NL-07-1389

**Edwin I. Hatch Nuclear Plant
Request to Implement an Alternative Source Term
Response to Request for Additional Information
Regarding the Radiological Consequences Analyses**

**Response to Request for Additional Information
Regarding the Radiological Consequences Analyses**

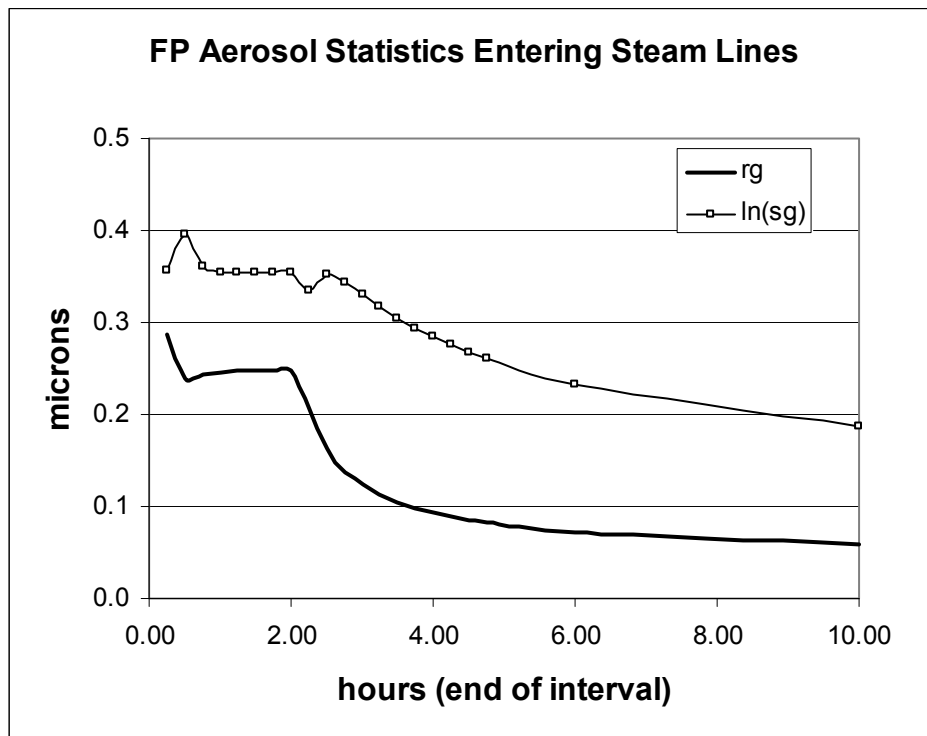
Appendix A, Section 6.1, of Regulatory Guide (RG) 1.183 states that "the activity available for release via MSIV leakage should be assumed to be that activity determined to be in the drywell for evaluating containment leakage (see Regulatory Position 3)." Regulatory Position 3 presents the source term, in the form of activity release fractions, released into containment. It is understood that this containment source term accounts for phenomena that would serve to inhibit activity release from the vessel, prior to transport through main steam and other bypass piping. The guidance of RG 1.183 further allows for the credit of other containment removal mechanisms (i.e., natural deposition and drywell spray); however, applying these additional removal mechanisms, prior, and in addition, to crediting pipe deposition, can substantially change the containment source term assumed to enter the main steam and other bypass piping, thus rendering the containment source term of Regulatory Position 3 inapplicable. Because the cumulative effect of these removal mechanisms was not explicitly addressed by the containment source term provided in Regulatory Position 3, consideration should be given to the interaction of each removal mechanism with the source term of RG 1.183 when modeling the transport of activity from the drywell through bypass pathways.

Therefore, please provide information to show that the cumulative effect of assuming the release of the containment source term, natural deposition, drywell spray removal, followed by pipe deposition, for the postulated LOCA at HNP, does not compromise the conservative characteristics of the dose analysis.

The post-LOCA size distribution of the aerosol entering the HNP steam line is shown in the following plot (geometric mean radius and natural log of the geometric standard deviation). This plot reflects the impact of drywell spray removal. Once the source ends at two hours, there is a significant decrease in

the aerosol size as the sprays remove the larger particles. There is also a general "tightening" of the size distribution (smaller sigma) during the entire spray removal period. However, there is a large decrease in the overall aerosol mass in the drywell associated with the transfer of mass from the drywell to the torus gas space immediately after the source is stopped (reflecting reflood and cooling of the damaged core). This transfer of mass reduces the effectiveness of the spray on the remaining airborne mass, and this effect is shown in the slight "spreading" of the size distribution (by aerosol agglomeration) as the calculated removal rate decreases.

Because of the rigorous capability of the STARNAUA code to calculate aerosol removal, and as importantly, the impact of that removal on the size distribution and deposition velocity of the aerosol remaining airborne, the cumulative effect of (1) assuming the release of the containment source term, (2) crediting drywell spray removal, and finally, (3) crediting removal by pipe deposition in the steam lines for the postulated LOCA at HNP does not compromise the conservative characteristics of the dose analysis.

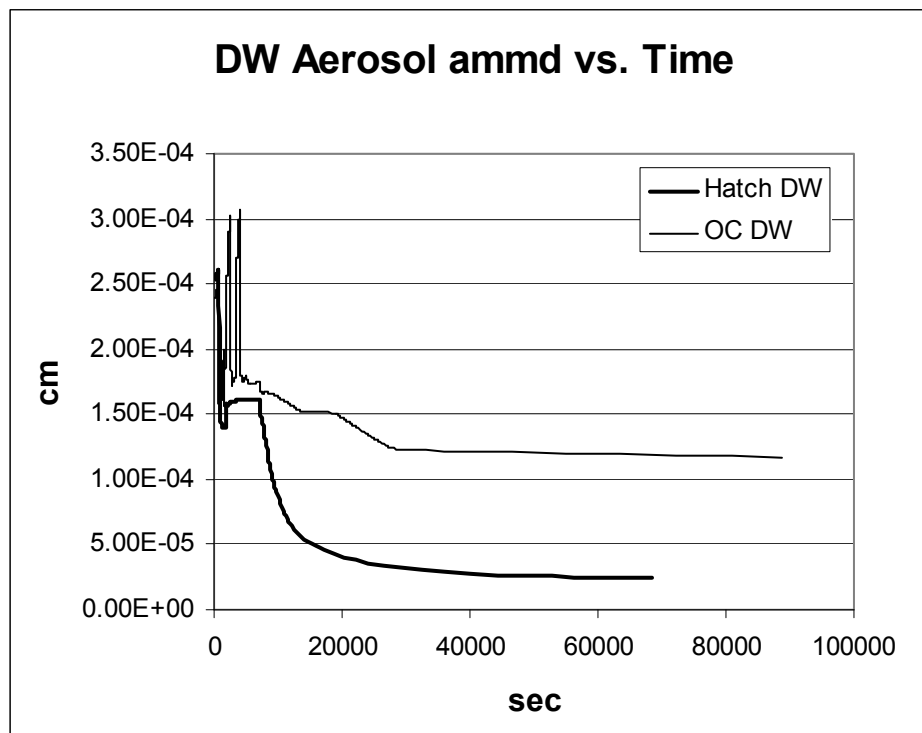
Therefore, please provide the effective decontamination factors associated with the individual aerosol removal mechanisms that were credited for the HNP LOCA analysis, and explain how the credit taken for aerosol impaction accurately accounts for the relatively low flow rate assumed and the settling of large particulate in the pipe length.

Looking at the first phenomenon (impaction at the entrance as opposed to plugging over time) in the context of the Oyster Creek RAI response, one may note a proprietary model was used to calculate a removal efficiency of ~50% (i.e., a DF of 2) for this phenomenon alone for the Oyster Creek single, closed MSIV. A comparison of the Oyster Creek drywell aerosol size distribution (expressed as the aerodynamic mass mean diameter or ammd) to that of HNP is as follows:

The distributions are initially similar except that the Oyster Creek sprays operate intermittently with the result that ammd “excursions” occur during the release phase at times that sprays are off. At the end of the release phase ($t = 7200$ seconds), the ammd values are only slightly different ($1.75\text{E-}4$ cm for Oyster Creek and $1.61\text{E-}4$ cm for HNP). The aerosol size is the key parameter for impaction at the entrance (assuming the flow is accelerating to sonic velocity), so one would expect that impaction efficiency at the end of the release phase would be comparable for the two applications. During the release phase, however, the Oyster Creek application would be expected to exhibit higher removal efficiencies.

Figure 4
Collection Efficiency at the Inboard MSIV as a Function of Time

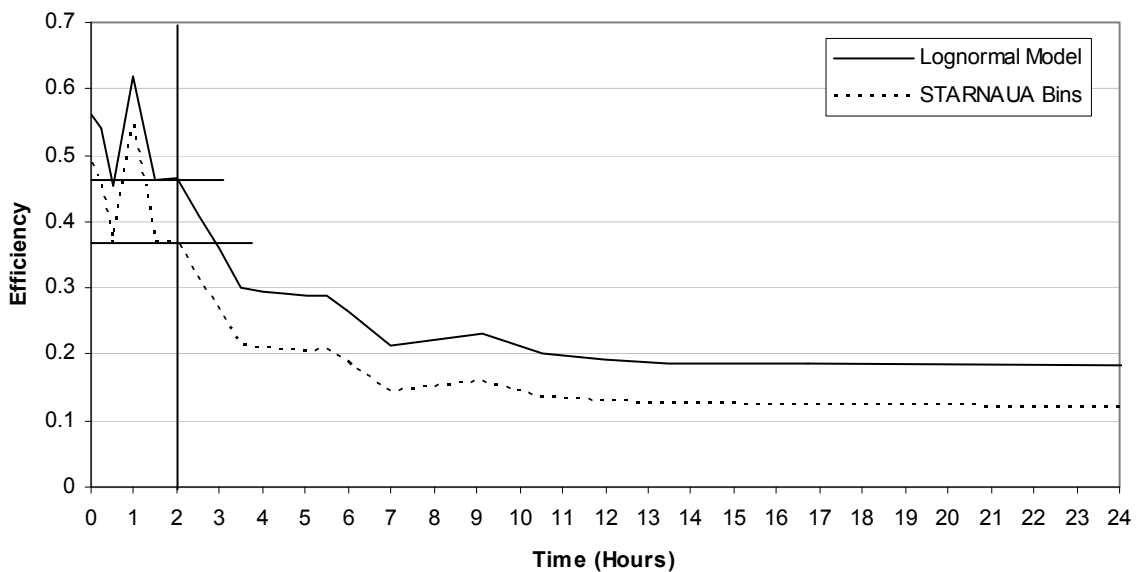
The phenomena referred to as impaction is generally assumed to take place under conditions characterized by relatively high flow rates and turbulence, where the concentration of airborne particulate, or aerosols, is substantial. For the release model used for HNP, impaction is credited; however, the assumed flow rate is low and potentially laminar, and particles settling in the pipe have been credited as well.

The entrance impaction removal efficiency for Oyster Creek at $t = 7200$ seconds (end of the release phase) is 37-47% and from 37-62% during the release according to the proprietary model previously applied to Oyster Creek (refer to “Figure 4,” presented below, from the Proprietary portion of the February 2001 Oyster Creek RAI response). The HNP removal efficiency during the release phase (based on the model applied to Oyster Creek) would be expected, therefore, to be in the range of 37-47% rather than 37-62%. Moreover, after the end of the release phase, the much higher (and continuous) spray removal rate assumed in the HNP aerosol transport analysis brings about an obvious divergence of the aerosol size distribution beyond $t = 7200$ seconds. Taken at face value, this would mean that one could not claim for HNP what was claimed for Oyster Creek, namely that based solely on entrance impaction (i.e., neglecting any plugging effects), a DF of 2 could be justified.

In fact, the proprietary analytical model applied to Oyster Creek (reflected in “Figure 4” above) was quite conservative, and it has been improved upon. It is

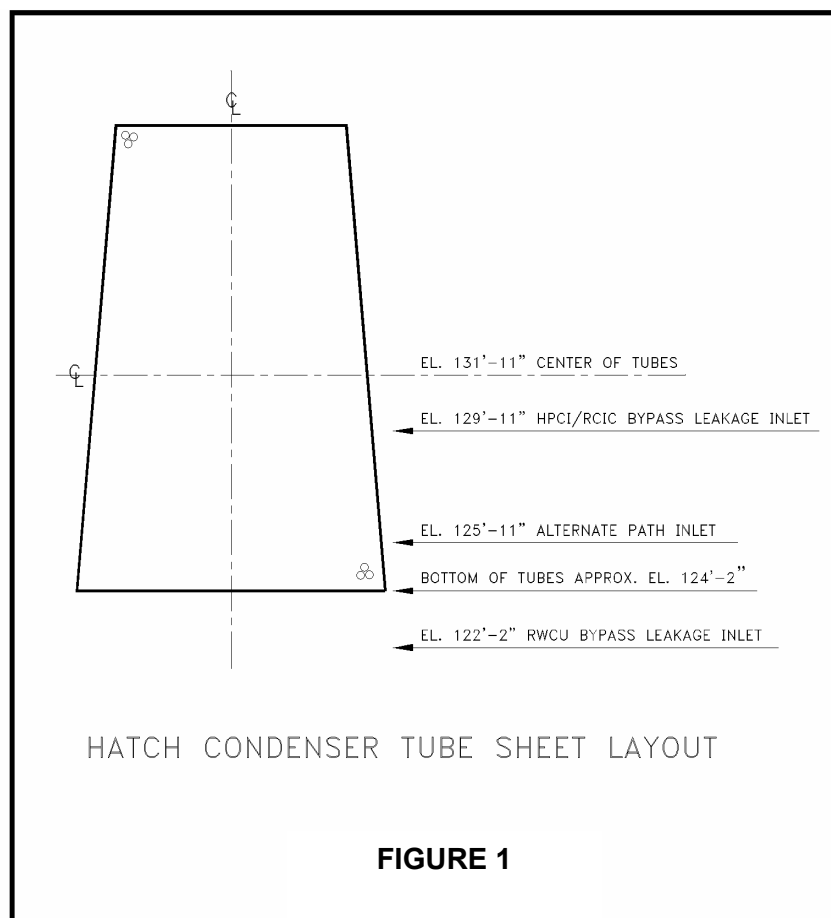
Please verify that all assumed secondary containment bypass pathways enter the condenser under the condenser tubes. If they do not, please justify the applicability of the condenser activity removal model, and activity removal credit associated with this release pathway.

Specifically for HNP, High Pressure Coolant Injection (HPCI) and Reactor Core Isolation Cooling (RCIC) system bypass leakage enters the condenser two feet below the center line of the tubes, the Reactor Water Cleanup (RWCU) system bypass leakage enters the condenser approximately two feet below the bottom of the tubes, and the MSIV alternate leakage treatment path inlet is six feet below the center line of the tubes and approximately 1'-8 1/2" above the bottom of the tubes. All inlets enter the condenser near horizontal cooling surfaces well below the top of the tubes.

The relative inlet locations are shown on Figure 1.

FIGURE 2 – MSL to CR Elevation

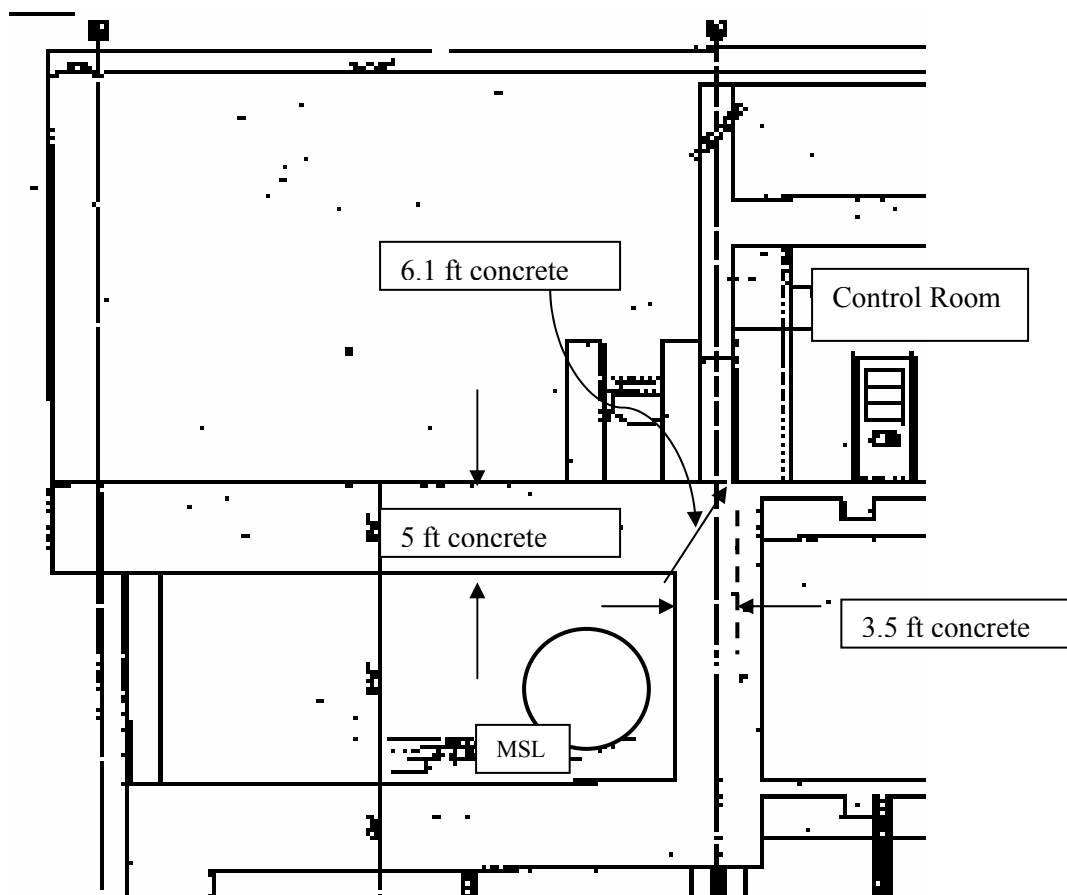
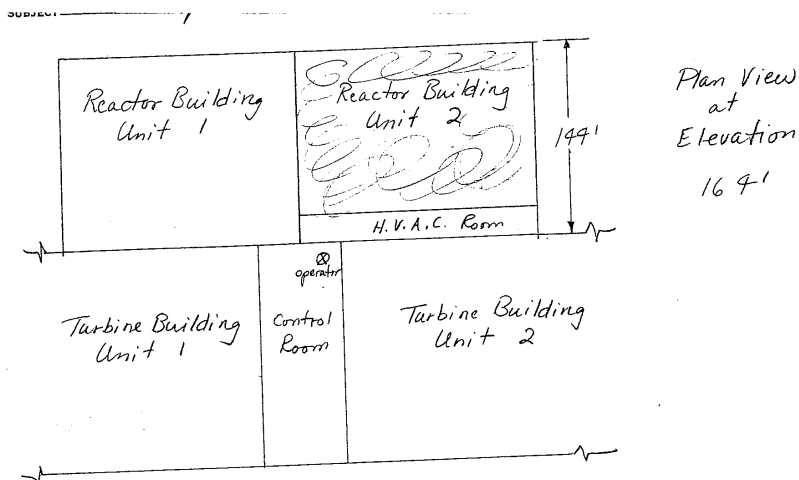
Please provide a detailed sketch showing the specific geometries used to model the shine dose to the MCR from external sources, including the airborne activity in the Turbine Building (TB), RB cloud, condenser, MCR filters, TB heating, ventilation, and air conditioning filters, and external plume. Also, please provide the parameters that thoroughly describe source and receiver characteristics (i.e., activity, density, composition, etc...) used to calculate the shine dose from the aforementioned contributors.

The main steam line (MSL) was modeled as an air-filled 2 ft diameter pipe with a 1.2 inch steel wall shielded from the control room by 6.1 ft of concrete as shown in Figure 2, with MSL source terms calculated as a function of time by the LocaDose computer program.

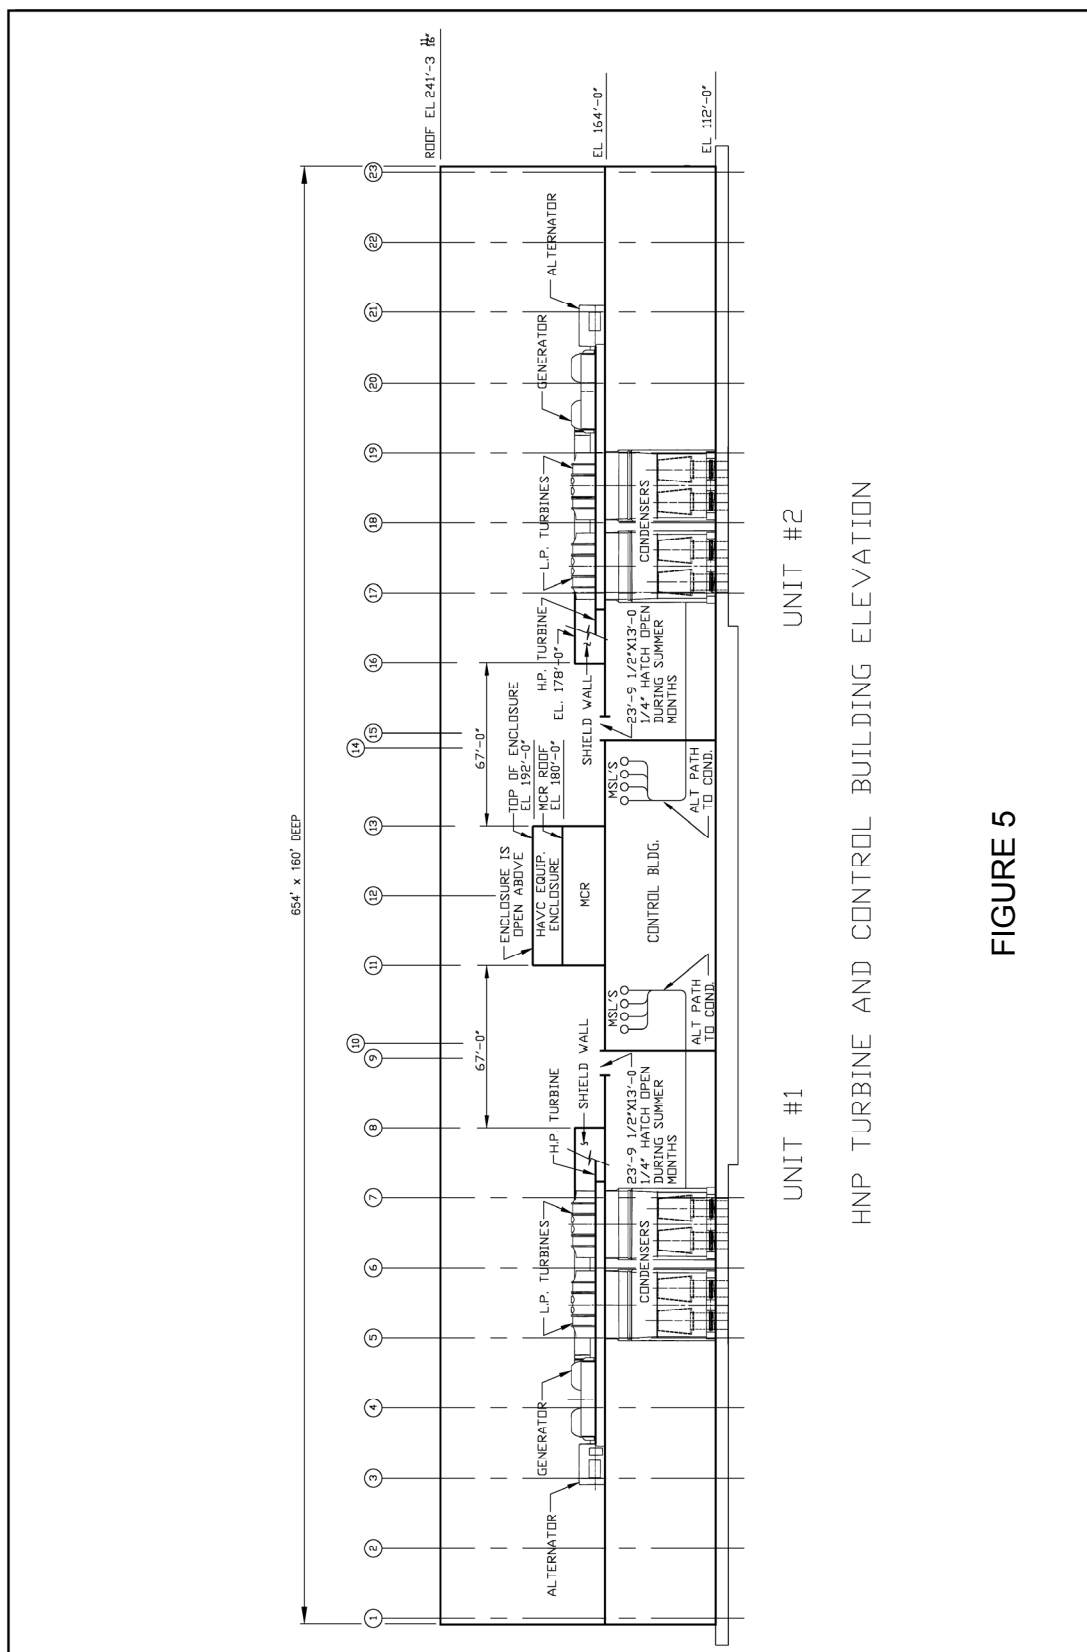
Under the assumed conditions, the activity leakage through the steam lines, to the condenser, and into the TB will take place at a relatively low flowrate (<3.0 cfm). Additionally, there is no credited safety, or non-safety grade, recirculation system in the TB volume. Therefore, this release scenario does not make it intuitively obvious that any thorough, flow-based, mixing will take place in such a way that the released activity becomes “uniformly mixed in the volume of the TB.”

So, please provide the justification for assuming that activity leaked into the TB will be uniformly mixed in the $6.5E6$ ft³ volume above the 164 ft elevation. Also, please provide justification for the assumed timing of any credited mixing in the TB volume.

The HNP MCR is the top elevation of the Control Building, at 164'. It is the same elevation as the operating floor of the turbine building, which is open to both units. The relative location of structures and components is shown in Figure 5. All steam line piping, the MSIV alternate leakage treatment pathway piping, the bypass piping, and the main condenser are located below elevation 164'. The top of the condenser is open to the turbine, which is an enclosed piece of equipment. The turbine is completely surrounded by a 14' high shield wall, the base of which is elevation 164'. Although most releases would originate below elevation 164', no credit was taken for any leakage into the volume below elevation 164'. The volume assumed available for mixing is limited to the volume above elevation 164' and below the TB roof.

The shield wall at the end of each high pressure turbine is approximately 67' from the MCR. As can be seen in Figure 5, migration of leakage toward the MCR would be from approximately 40% of the volume above the 164' elevation on the accident unit to the approximately 60% of the volume containing the MCR and the non-accident unit. The majority of leakage being below elevation 164', not crediting the volume below elevation 164', and the distance from the turbine enclosure shield wall to the MCR will all contribute to inhibiting transport of the leakage to the MCR. Thus, the leakage would have to disperse through the TB and spread toward the MCR. Other than the MCR and the turbine shield walls, there are no major obstructions or discontinuities to diffusion or air flow on the operating floor of the TB. Thus, transport from the TB toward the MCR would continue to the remaining $>60\%$ volume of the turbine building, assuming no mixing in the opposite direction.

Based on the dimensions shown in Figure 5, the free volume of the TB above elevation 164' is approximately $8.1E6$ ft³. The LOCA radiological consequence analysis uses a more conservative TB free volume input of $6.5E6$ ft³. The LOCA analysis also assumes uniform mixing within the volume of the TB occurs instantaneously without holdup or decay during transport to the TB volume containing the MCR. Thus, based on the physical configuration, the

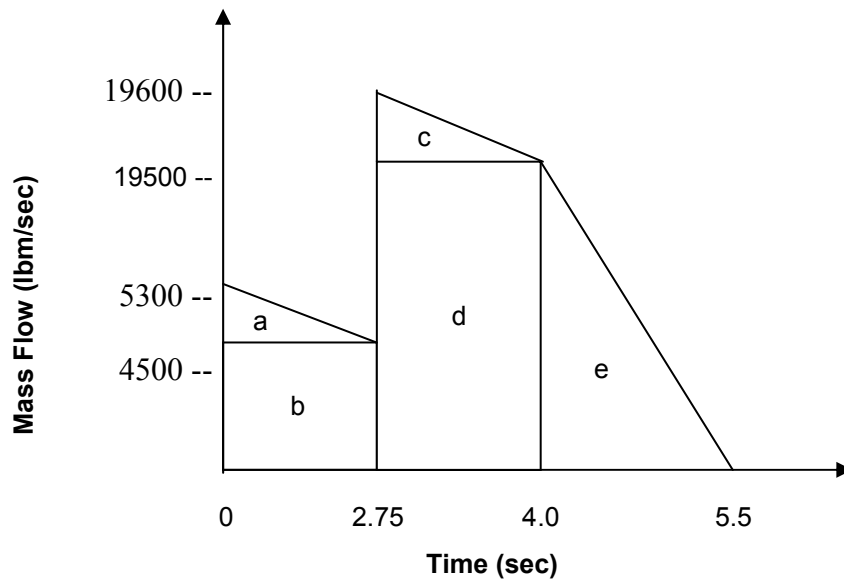
Enclosure 1, Table 30, of the August 29, 2006, submittal indicates that the total mass of the post-accident steam blowdown is 68,174 lbm. Please clarify what fraction of the total coolant blowdown mass forms the post-accident plume of activity.

In Table 30, the fluid mass shown as being released at an enthalpy of 1191.5 Btu/lbm within the first 2.75 sec of the break is steam. The subsequent release to 5.5 sec is a mixture of steam and liquid. The following figure shows the mass flow rate as a function of time:

The sections of the figure are integrated as follows to obtain the total mass released:

Assuming 7% of the mixture mass of 3.91E4 lbm is steam and adding this to the direct steam release yields a total steam release of 1.62E4 lbm. For the remaining 93% of the mixture that is in liquid form, a flashing fraction of 0.42 is calculated assuming a constant enthalpy process at 14.7 psia and 212 °F, yielding a flashed steam mass of 1.54E4 lbm. The total mass of steam that is released is 3.16E4 lbm, thereby releasing all the activity contained within this mass.
